HIGHWAY WORK PROPOSAL

<u>COUNTY</u>	<u>STATE PROJECT</u>	<u>FEDERAL</u>	<u>PROJECT DESCRIPTION</u>	<u>HIGHWAY</u>
Racine	3763-00-74	N/A	CTH KR, V Mt Pleasant; CTH H To Old Greenbay Road	CTH KR

ADDENDUM REQUIRED ATTACHED AT BACK

PROJECT NO: 3763-00-74	Hwy: CTH KR	COUNTY: RACINE	PAVING GRADES	SHEET 143
FILE NAME : S:\DOT\DOT_SE\180045_Foxconn\Local_Roads\Des\ign\00N_Files\CTH KR East\Plan\Sheets\021268_PG.dgn				
PLOT DATE : 6/29/2020				
PLOT BY : RWOLK				
PLOT NAME :

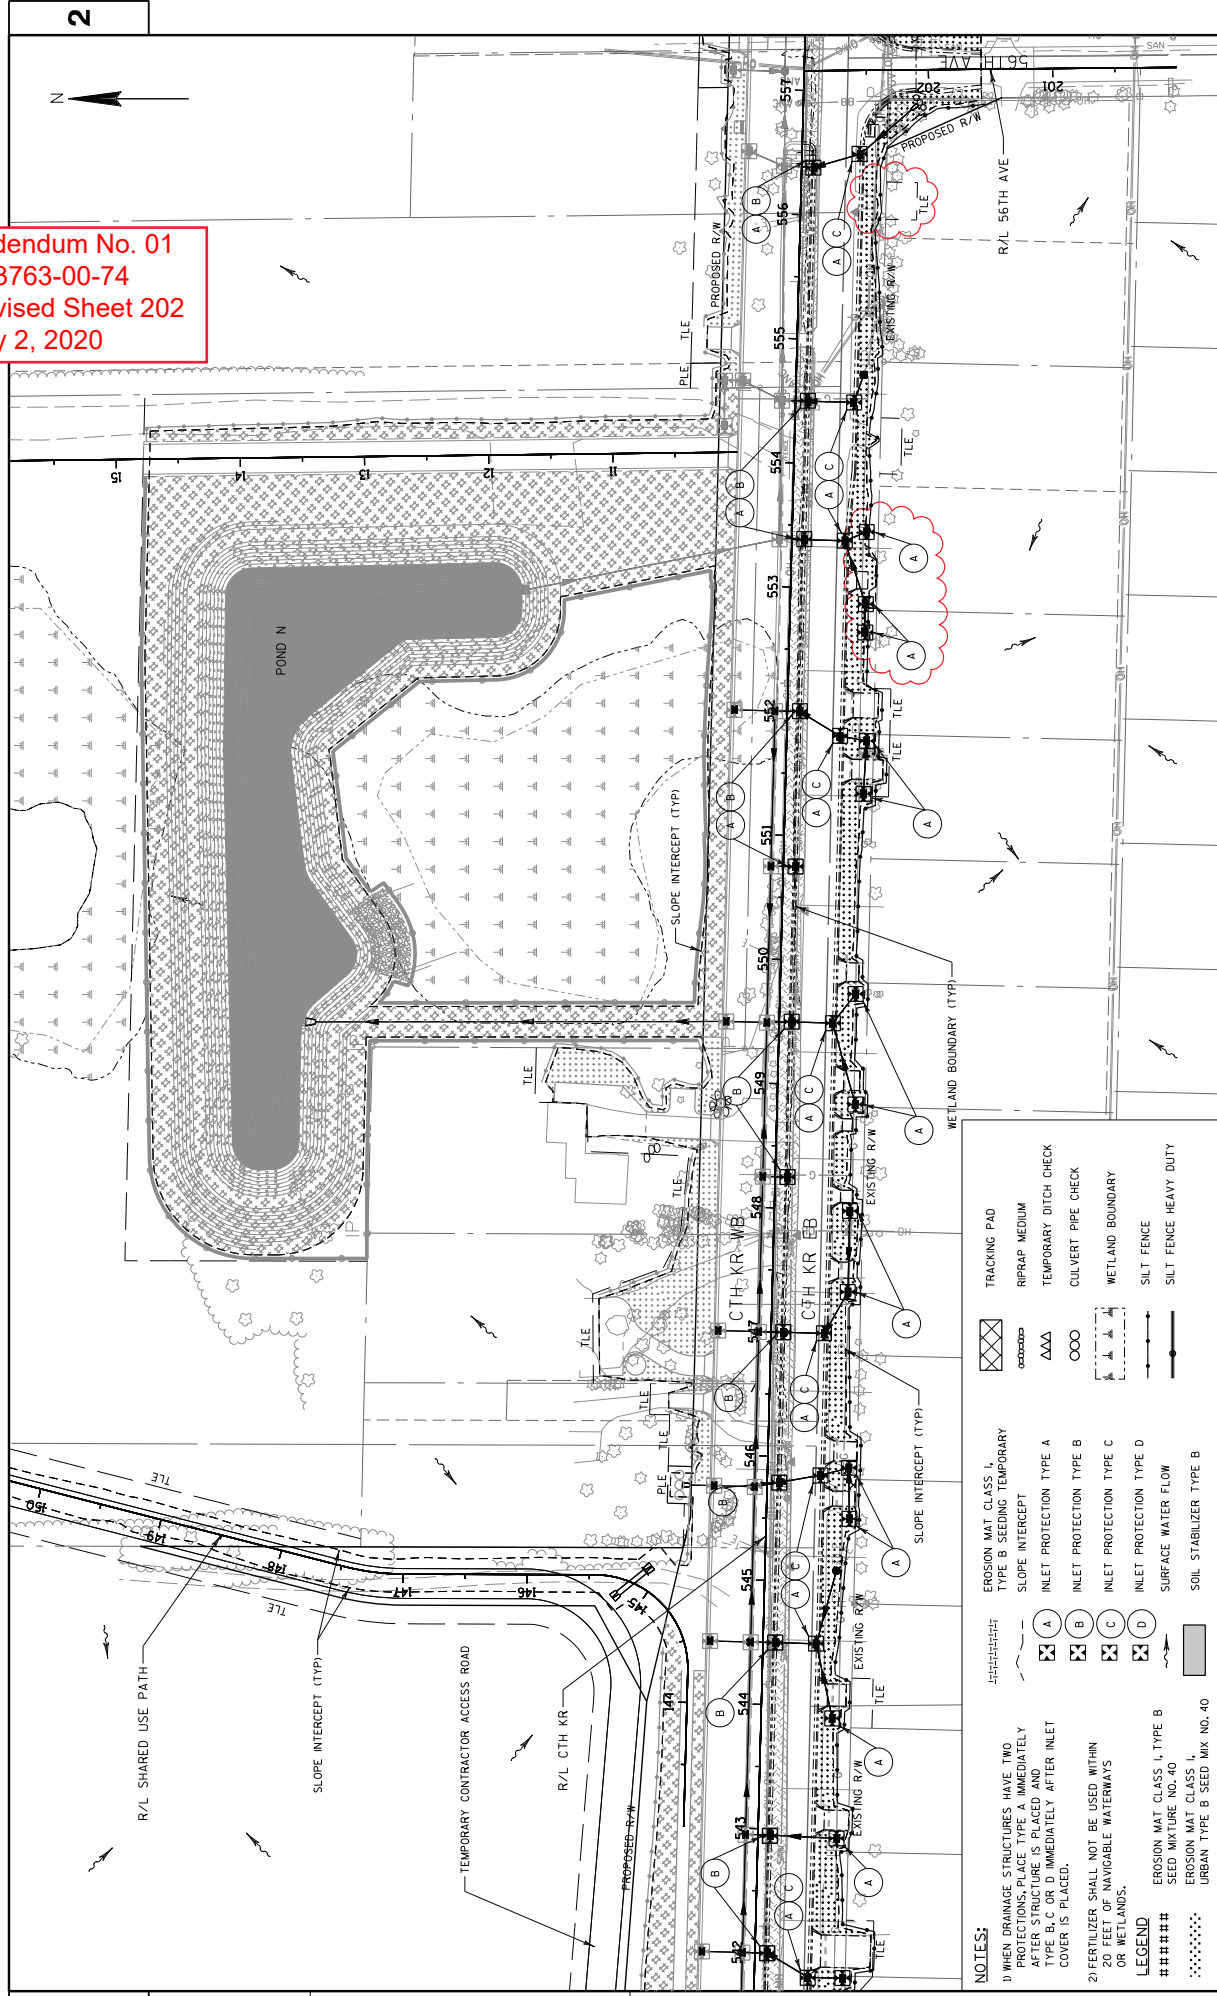
Addendum No. 01
ID 3763-00-74
Revised Sheet 105
July 2, 2020

- NOTES:**
- 1) CURB AND GUTTER GRADES ARE GIVEN TO THE FLANGE OF CURB AND GUTTER.
 - 2) PAVING GRADES ARE SHOWN AT 25' INTERVALS.
 - 3) SEE CURB RAMP DETAILS FOR ADDITIONAL GRADES.
 - 4) REFER TO PLAN DETAILS FOR INFORMATION
- LEGEND**
- XXX.XX = SPOT ELEVATION
 - XXX.XXR = END OF RADIUS ELEVATION
 - = PROPOSED INLET
 - = PROPOSED MANHOLE

PROJECT NO: 3763-00-74	COUNTY: RACINE	STORM SEWER PLAN AND PROFILE: CTH KR	SHEET 236
FILE NAME : S:\DDOT\DOT_SE\180045_Foxconn\Local_Roads\Ues\IGN\UON F_Lies\CTH KR Eos\Plan\Sheets\022507_SS.dgn	HWY: CTH KR	PLOT DATE : 6/29/2020	PLOT SCALE : 1:100
		PLOT BY : WWLOK	WISDOT/CADD SHEET 41

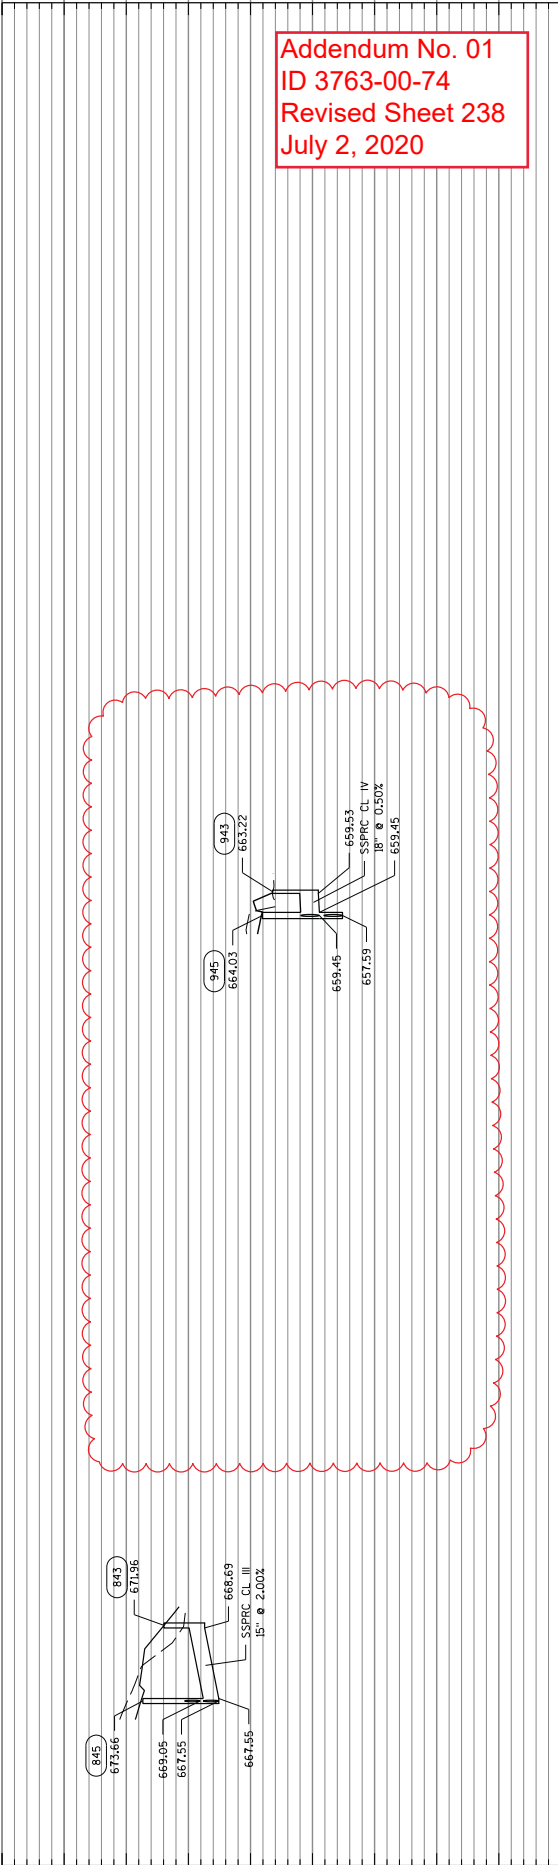
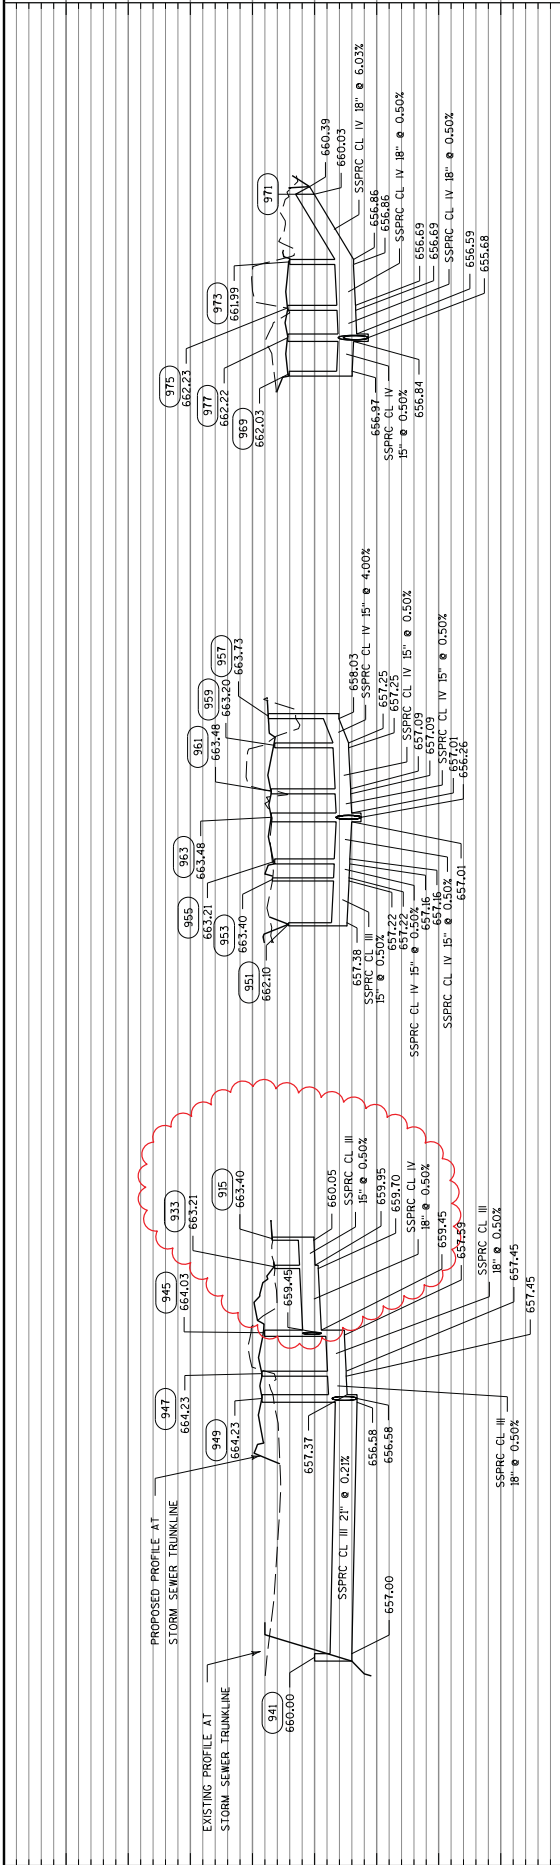
Addendum No. 01
ID 3763-00-74
Revised Sheet 236
July 2, 2020
